12. COUNCIL REPORTS FOR DECISION**12.1. PORT LINCOLN TOWN JETTY SWIMMING ENCLOSURE**

REPORT INFORMATION	
Report Title	Port Lincoln Town Jetty Swimming Enclosure
Records Reference	9.24.1.2 REP23117
Organisational Unit	Environment & Infrastructure
Responsible Officer	Project Manager - Master Plan Projects - Kathleen Brannigan
Report Attachment/s	Yes Attachment 8 I223976 Assessment Report on Town Jetty Swimming Enclosure (June 2022) I231611 Peer Review of Assessment Report on Town Jetty Swimming Enclosure (July 2023)
REPORT PURPOSE	
The purpose of this report is to provide Council with a report about the current swimming enclosure pontoon structure at the Port Lincoln Town Jetty and recommend next steps.	
REPORT DECISION MAKING CONSIDERATIONS	
Council Role	Owner / Custodian - Manage community assets including buildings, facilities, public space, reserves on behalf of current and future generations
Strategic Alignment	SDP GOAL: Goal 5: Community Assets and Placemaking SDP ACTION: Not Applicable

**ASSESSMENT REPORT ON TOWN
JETTY SWIMMING ENCLOSURE
(JUNE 2022)**

**PEER REVIEW OF ASSESSMENT
REPORT ON TOWN JETTY
SWIMMING ENCLOSURE (JULY 2023)**

Figure 1: Image obtained from internet search showing an estimated 0.5-0.6m wave event at the swim enclosure.

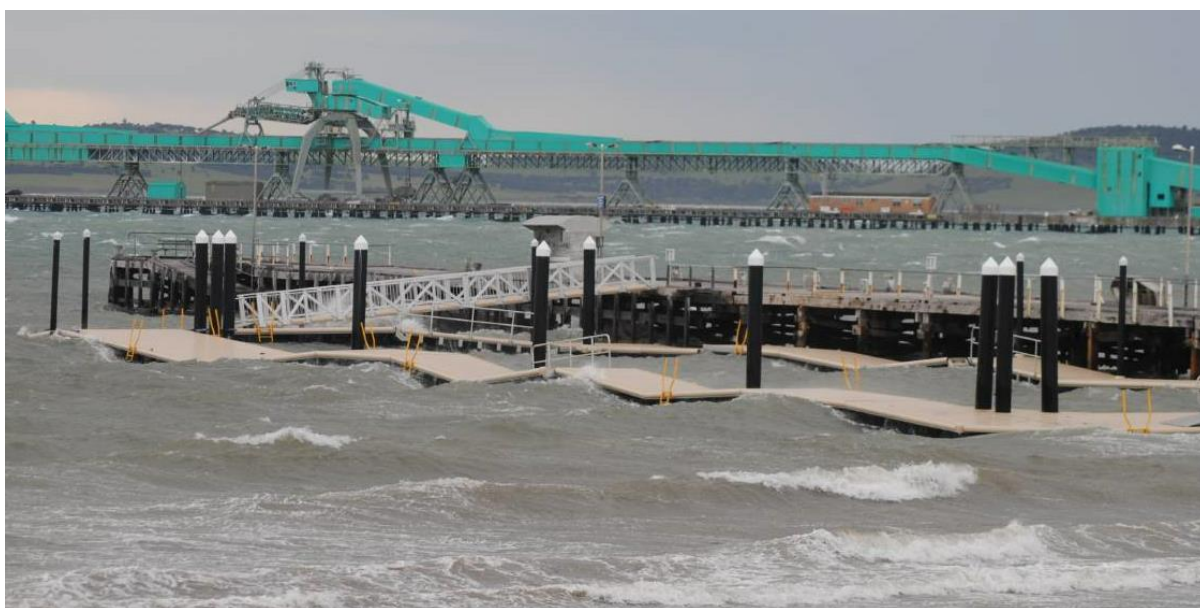
Imagery of the swim enclosure found on the internet suggests a 0.5-0.6m wave is likely to have occurred. An example is shown below however the date the image was taken cannot be confirmed.

The report discusses the manner in which waves can partly suspend the pontoons as they pass. However the hinge joints between the pontoons are provided to address this and reduce the loads on the pontoon framing as shown in Figure 1. The report does not mention this or discuss why the hinge joints did not prevent damage.
